Re: Transmittal of Response to Comments made by Dignity Health-Mercy Hospital on the Final Environmental Impact Statement for the California High-speed Rail, Fresno to Bakersfield Section (CEQ# 20140125)

Responses to Comments
Borton Petrini, LLP (representing Dignity Health-Mercy Hospital)
Letter Dated April 30, 2014

Figure 1
Distance from Bakersfield Hybrid Centerline to Mercy Hospital

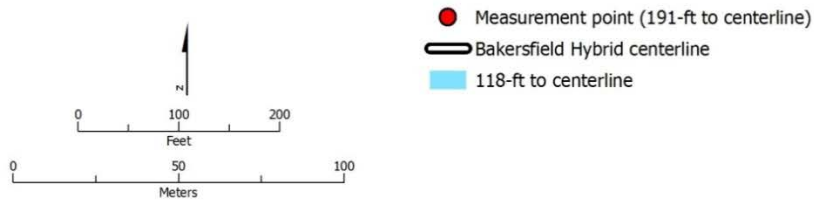
According to a figure provided with Mercy Hospital's June 28, 2013 letter, the location of the centerline of an alignment was approximately 118 feet from the nearest building face of Mercy Hospital. The alignment was not labeled in the figure provided by Mercy Hospital. However, none of the alignments evaluated in the Final EIR/EIS are located 118 feet from the centerline of track to Mercy Hospital. The location of the nearest project centerline (B2 – Bakersfield South) to the nearest building face of Mercy Hospital is 185 feet. Figure 1, "Distance from Bakersfield Hybrid Centerline to Mercy Hospital" shows that the distance of the Preferred Alignment is 191 feet from the nearest building face of Mercy Hospital.

Note: The Bakersfield Hybrid was identified in the Final EIS as the Preferred Alternative. Bakersfield South Alignment is 185 feet from Mercy Hospital.
